## CITY OF ALBUQUERQUE

RE: Lot 6 Block 4 Volcano Cliffs Unit 22 SAD 228 6408 Papagayo Dr. NW Grading and Drainage Plan Engineers Stamp Date 5/20/2021 (D10D003D6) Pad Certification Date 7/22/2021

GRADING AND DRAINAGE PLAN

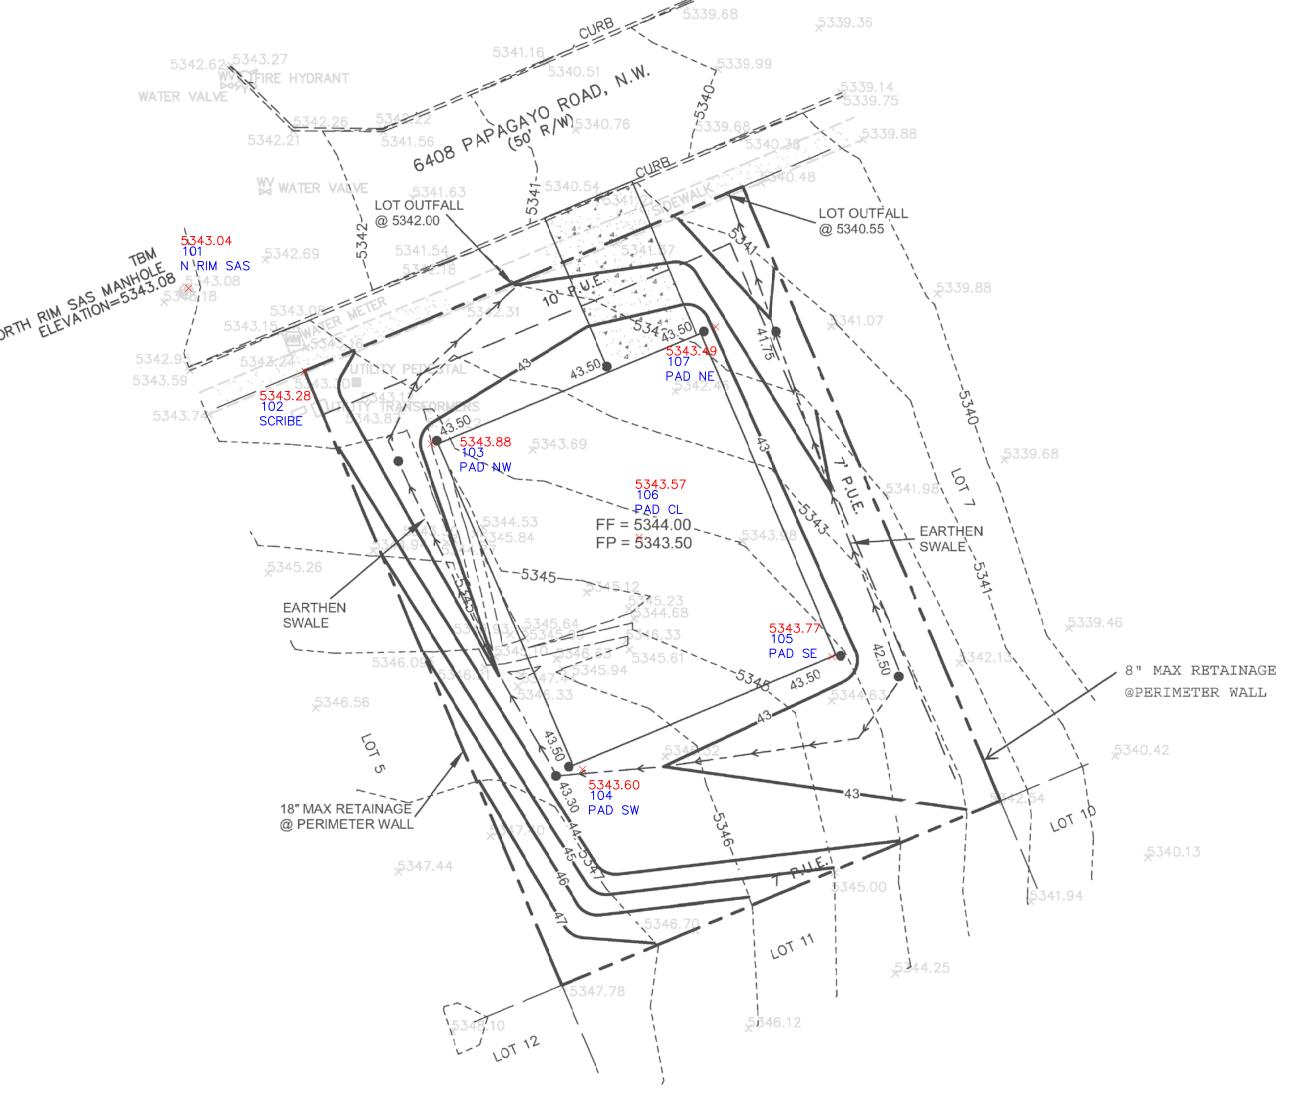
Reiterate to the Owner/Contractor that a separate permit for a garden/retaining wall must be obtained, with the approved G&D plan and Pad Certification. Also, let the owner/contractor know that if a pool is to be added in the future the G&D plan will need to be modified showing the location of the pool and the land treatment differences.

Prior to Certificate of Occupancy release, Engineer Certification per the DPM checklist of this plan will be required.

Based upon the information provided in your submittal received 7/23/2021, this plan is approved for Building Permit.
